re: Grading and Site Servicing Plans Review
Proposed 4-Storey Apartment Building
2928 Bank Street – Ottawa, Ontario
to: VIP Construction and Engineering – Dimitri Zeidan – dzeidanvip1@gmail.com
date: December 6, 2024
file: PG7073-MEMO.01

1.0 Grading Plan Review

2.0 Site Servicing Plan Review

Figure 1 - Markup Grading Plan Indicating The Location of Required Insulation for Footings

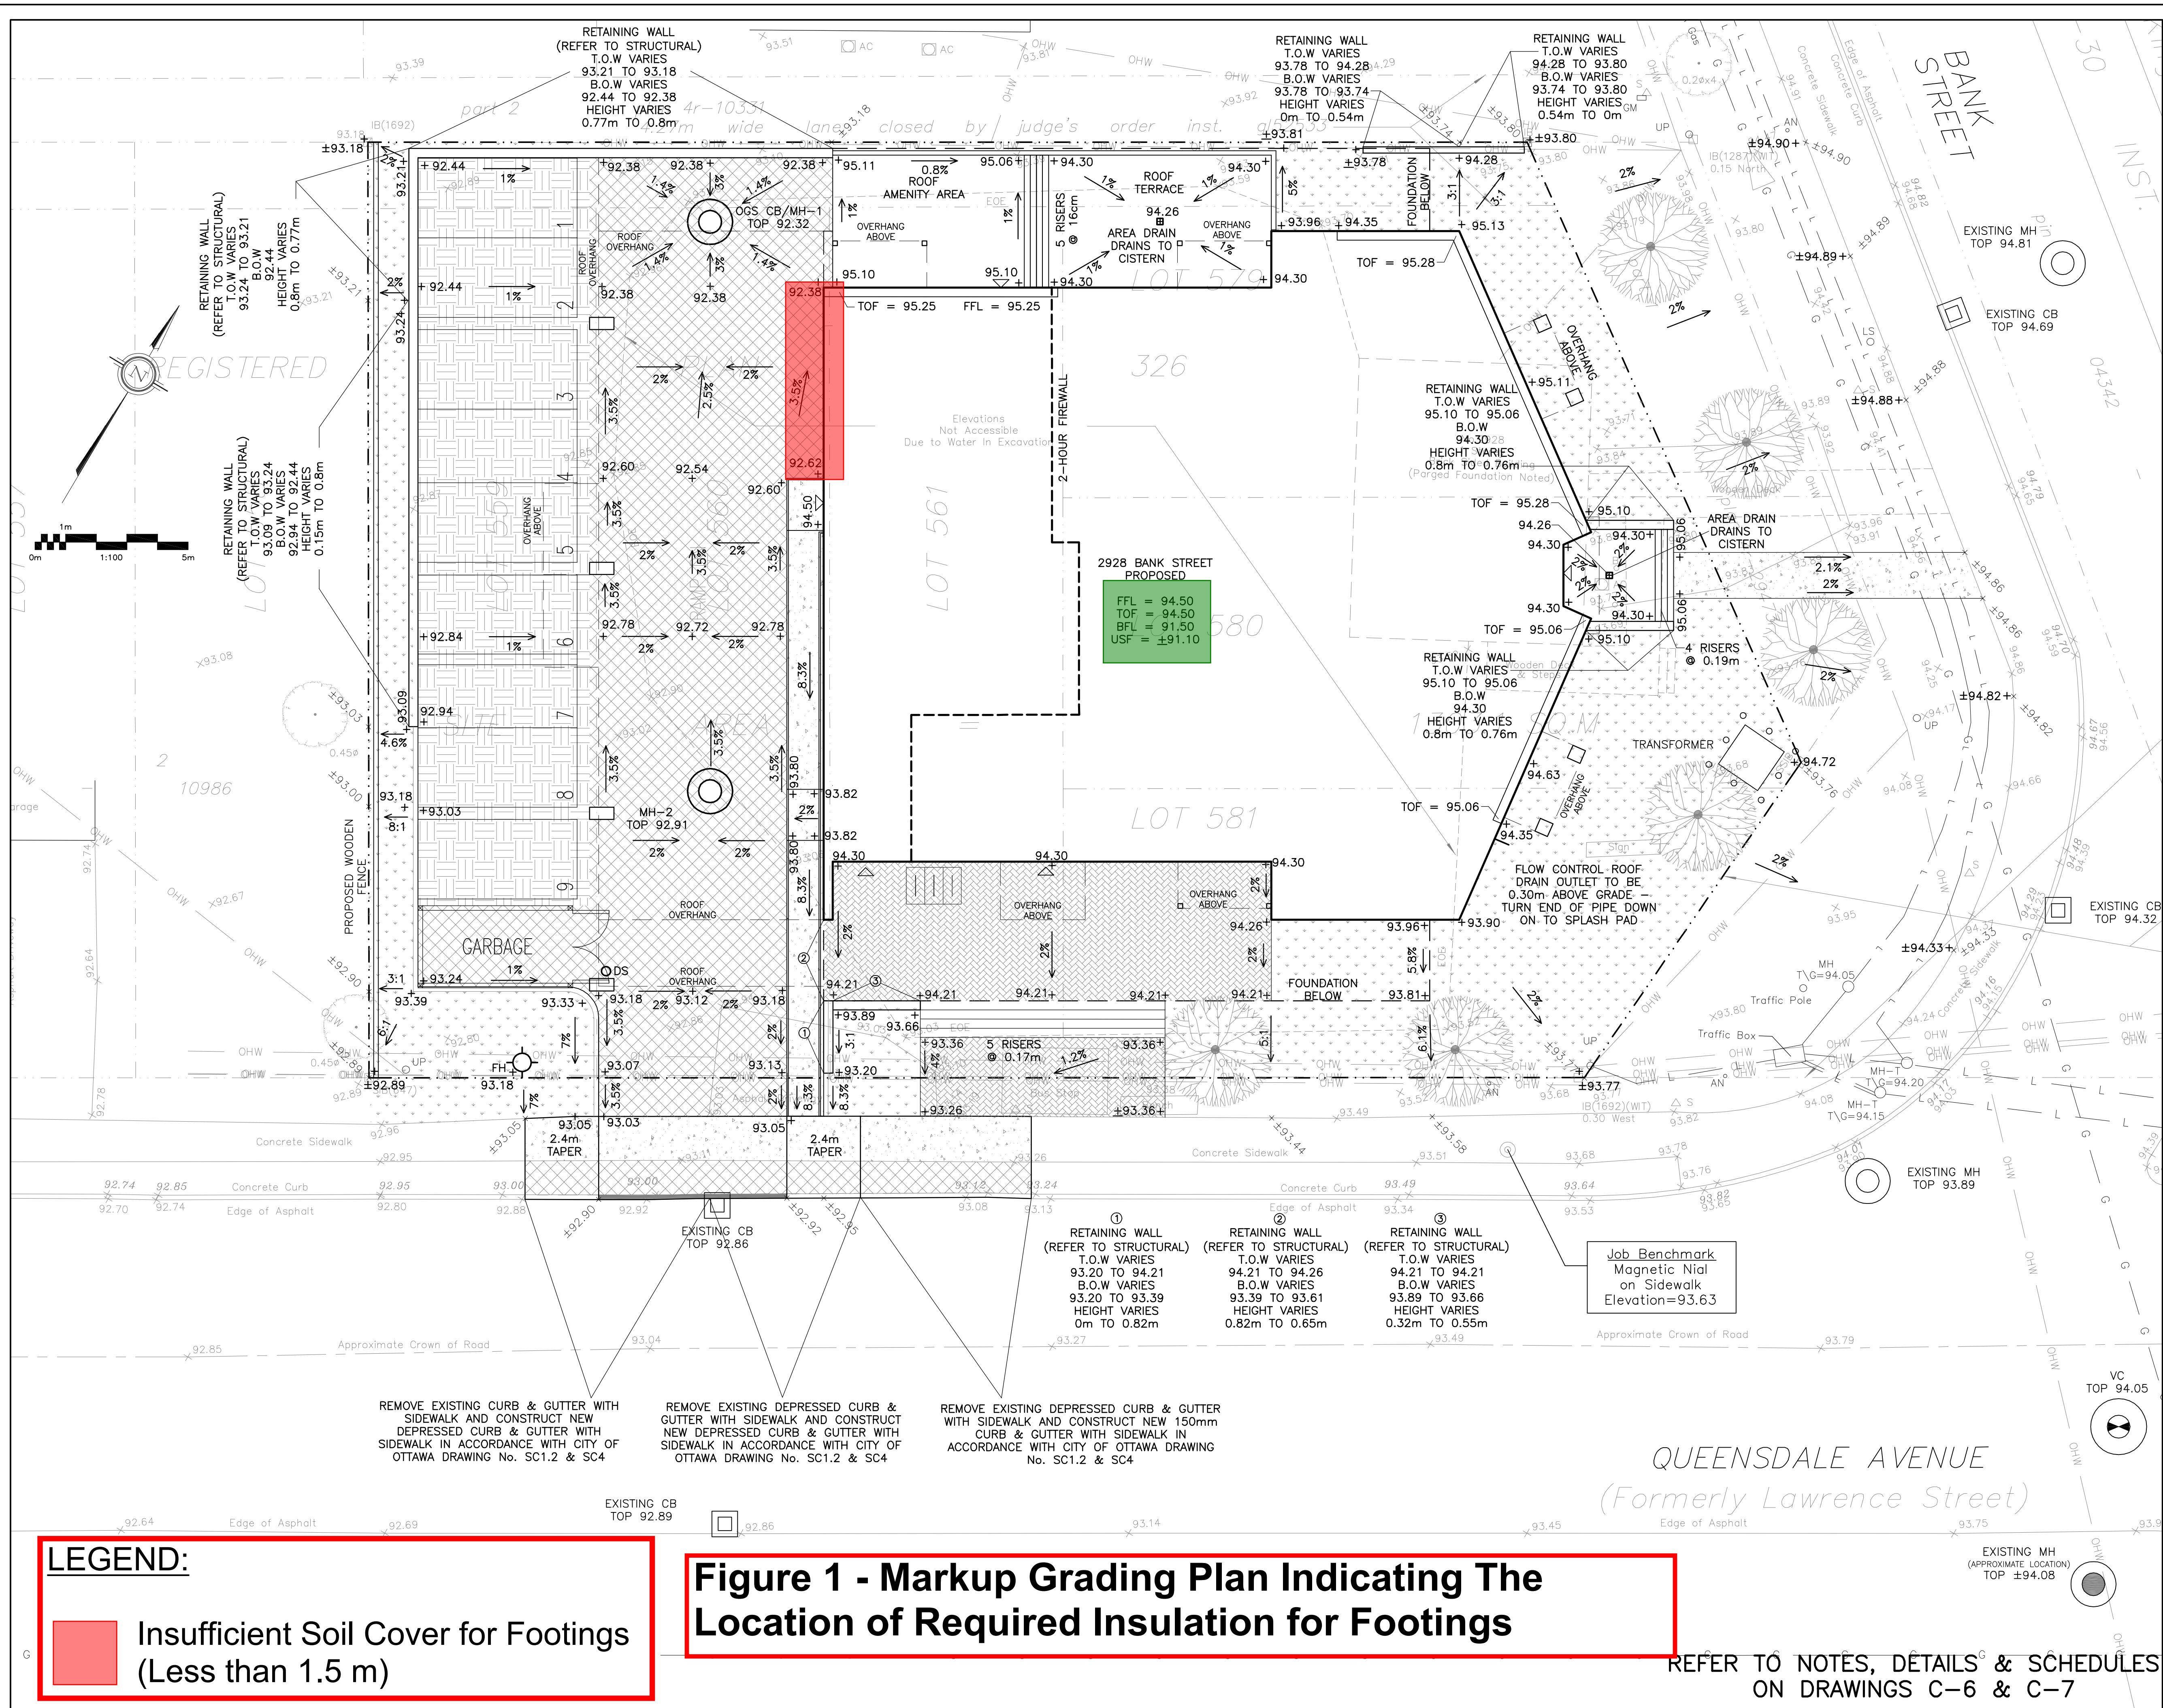
Based on our review of above noted grading plan, it should be noted that some of the perimeter footings for the proposed development are provided by insufficient soil cover. References should be made to Figure 1 – Mark Up Grading Plan Indicating The Location of Required Insulation for Footings.

It should be noted that to accommodate the absence of sufficient frost cover (minimum 1.5 m for heated footings) for the proposed footings, a different form of frost protection should be provided. This can be achieved by means of rigid insulation. Where insufficient soil cover is present above the underside of footings, the rigid insulation recommendations should be followed, as provided in Table 1 in the following.

RIGID INSULATION CONSISTING OF HI40, OR APPROVED EQUIVALENT, BE INSTALLED DIRECTLY BELOW THE PROPOSED FOOTINGS. REFERENCE SHOULD BE MADE TO "PG7073-MEMO.01-TABLE 1" FOR INSULATION DIMENSIONS, INCLUDING THICKNESS.

THE RIGID INSULATION SHOULD EXTEND HORIZONTALLY ON THE EXTERIOR SIDE AND A MINIMUM OF 600 MM HORIZONTALLY ON THE INTERIOR SIDE BEYOND THE FOOTING FACE AND SHOULD CONSIST OF SM RIGID INSULATION. REFERENCE SHOULD BE MADE TO "PG7073-MEMO.01-TABLE 1" FOR INSULATION DIMENSIONS, INCLUDING THICKNESS AND EXTENSION ON THE EXTERIOR SIDE.

Figure 3 - Markup Site Servicing Plan for The Location of Pipes Where Insulation Will Be Required

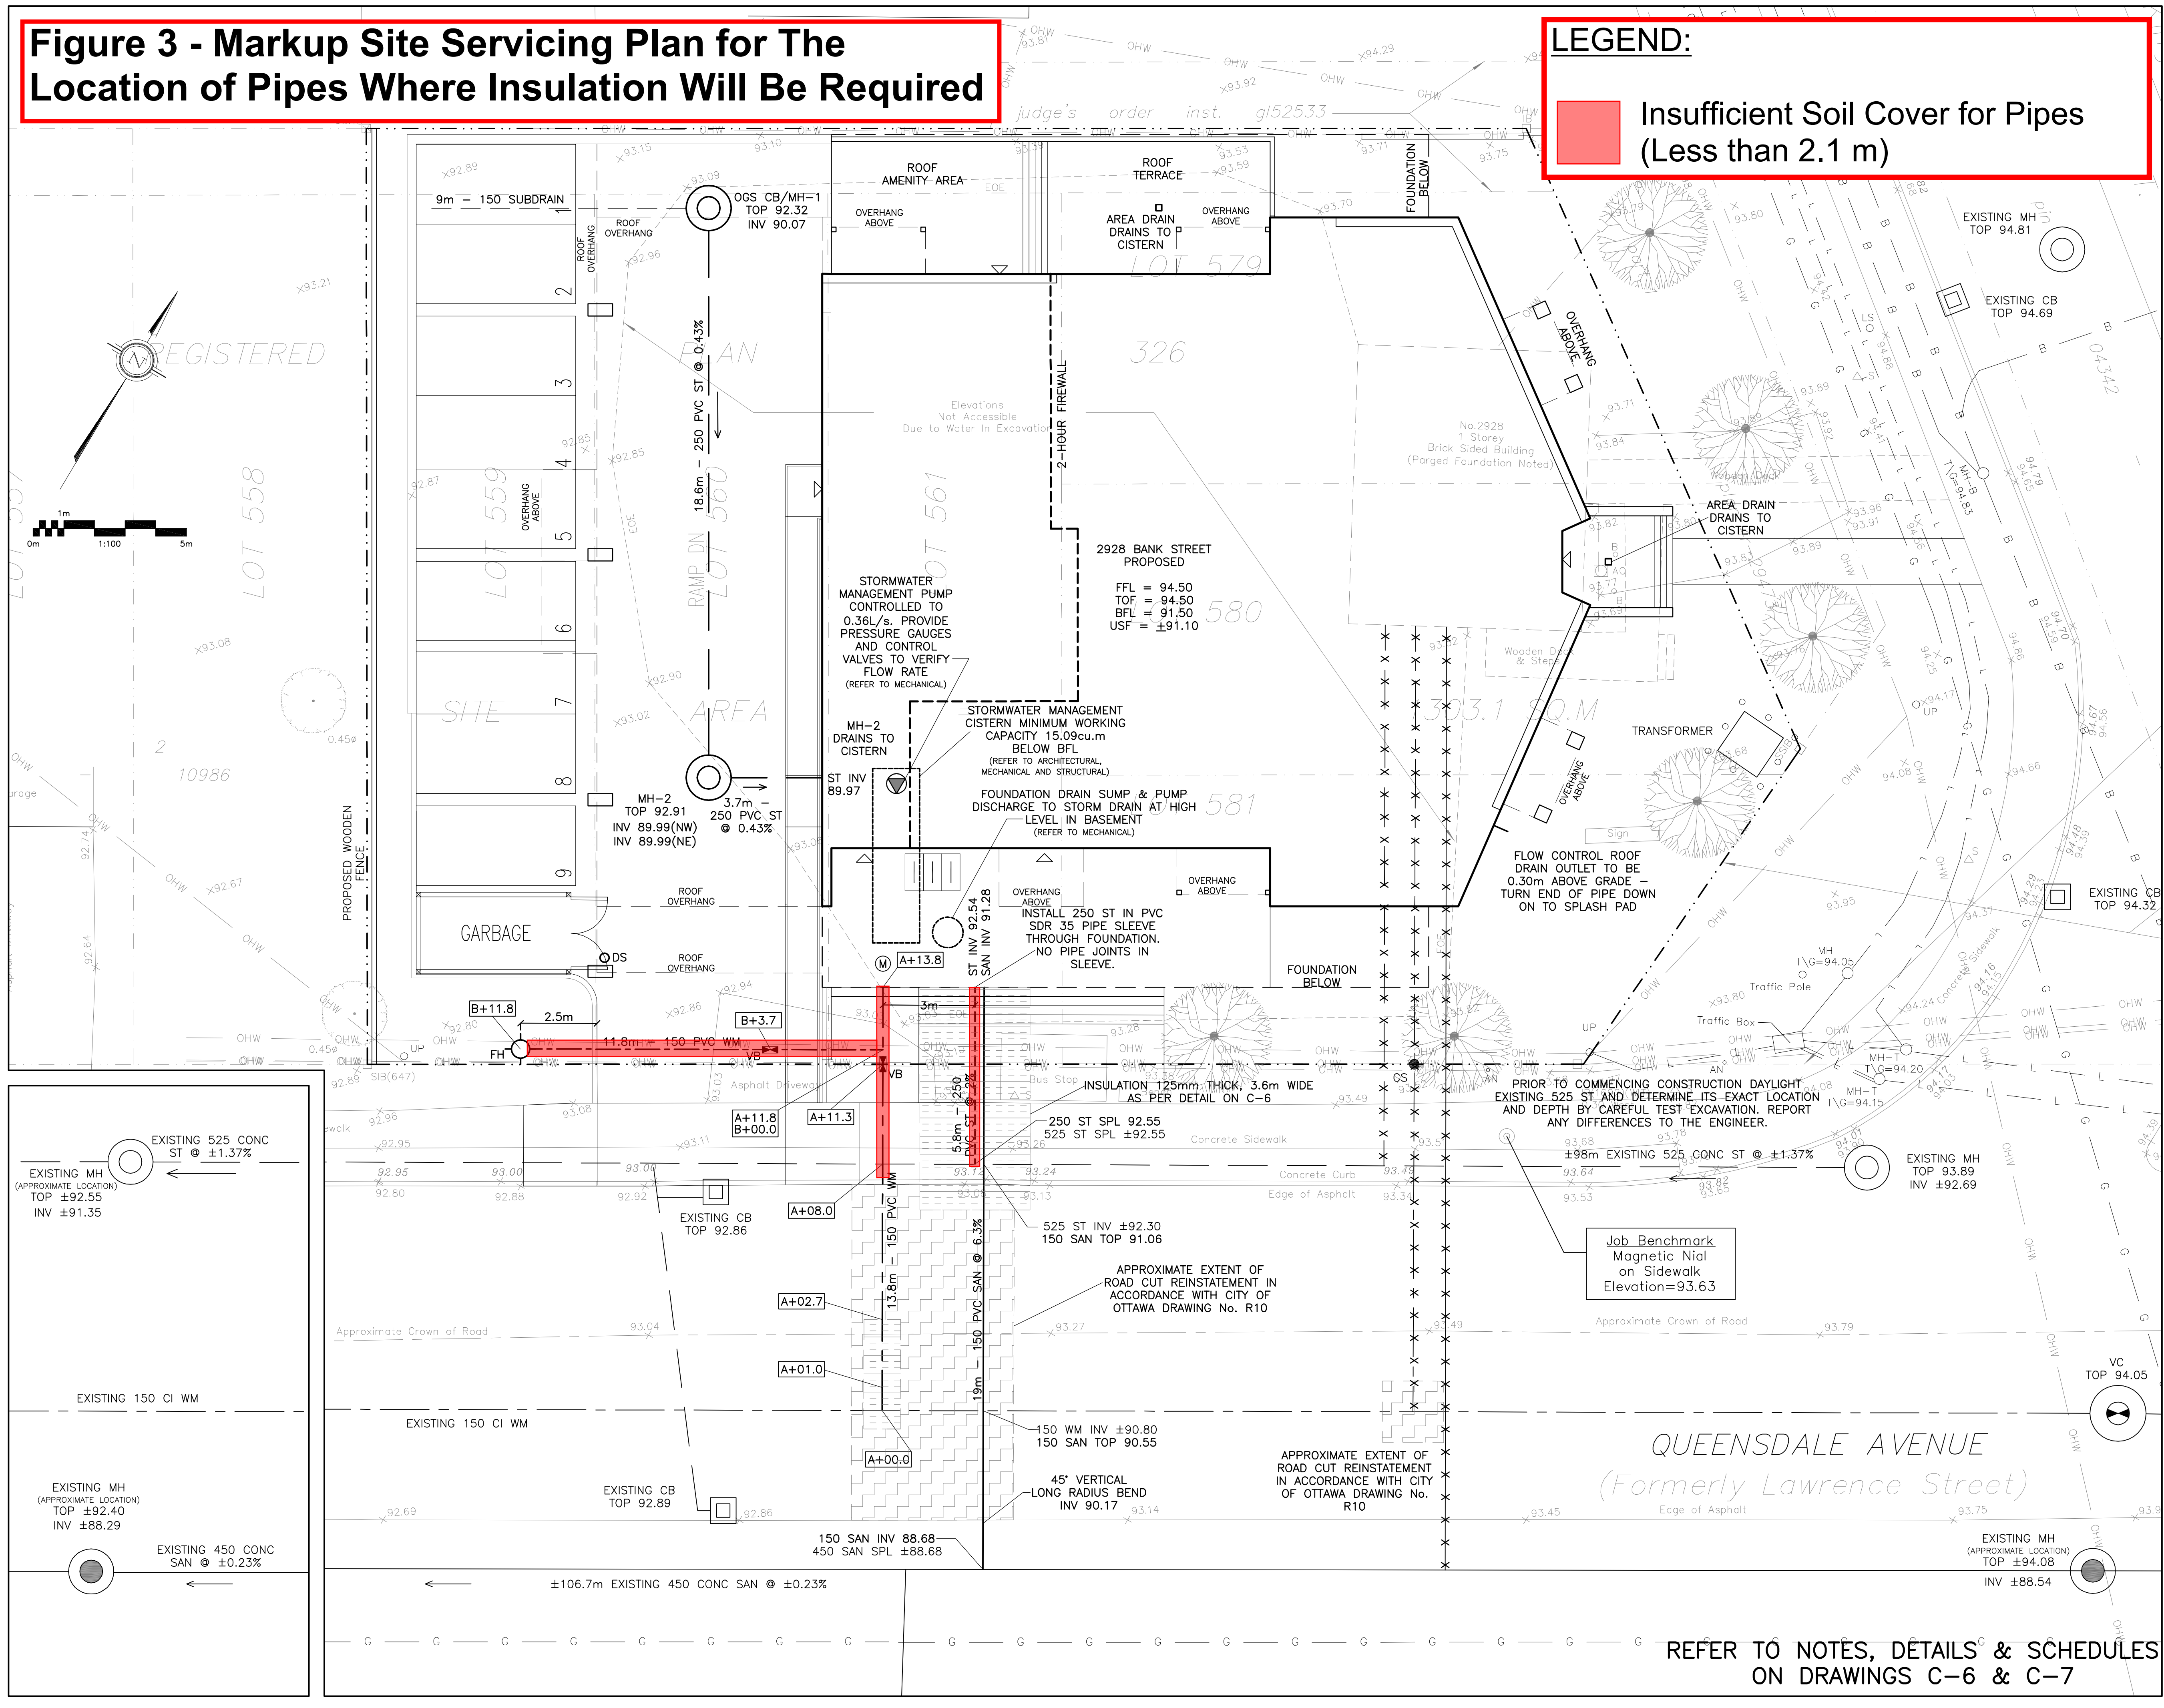
Based on our review of the above-noted site service plan, it should be noted that all services will be constructed outside the lateral zones of the proposed footings of the building and are considered to be acceptable from a geotechnical perspective. However, insufficient frost protection has been provided for the proposed storm sewer pipe throughout the subject site.

Reference should be made to Figure 3 - Markup Site Servicing Plan for The Location of Pipes Where Insulation Will Be Required, attached to this memorandum.

It should be noted that the aforementioned storm sewer pipe is located within the frost zone, approximately within 2.1 m below the finished grade. In the following section, frost protection of the site servicing is recommended where insufficient frost cover has been provided.

Any portion of the services installed at a depth of 2.1 m below the finished grade or deeper is considered to have sufficient soil cover for frost protection. Where insufficient soil cover is present above the invert of storm sewer pipe, the following frost protection criteria should be followed:

Table 2 - Rigid Insulation Recommendations for Storm Sewer Pipes with Reduced Soil Cover			
Thermal Condition	Soil Cover Provided (mm)	Insulation Dimensions	
		Thickness (mm)	Extension (mm)
Unheated	600 to 900	125	Extend 1200 mm horizontally beyond edge face of the pipe
	900 to 1200	100	Extend 1200 mm horizontally beyond edge face of the pipe
	1200 to 1500	75	Extend 900 mm horizontally beyond edge face of the pipe
	1500 to 1800	50	Extend 600 mm horizontally beyond edge face of the pipe
	1800 to <2100	25	Extend 300 mm horizontally beyond edge face of the pipe
Notes: <ul style="list-style-type: none">- All designs are based on a freezing index of 1000°C-days- The rigid insulation thicknesses and extensions provided herein are site specific and should not be used on other sites without consulting Paterson Group for the sufficiency of the provided recommendations.
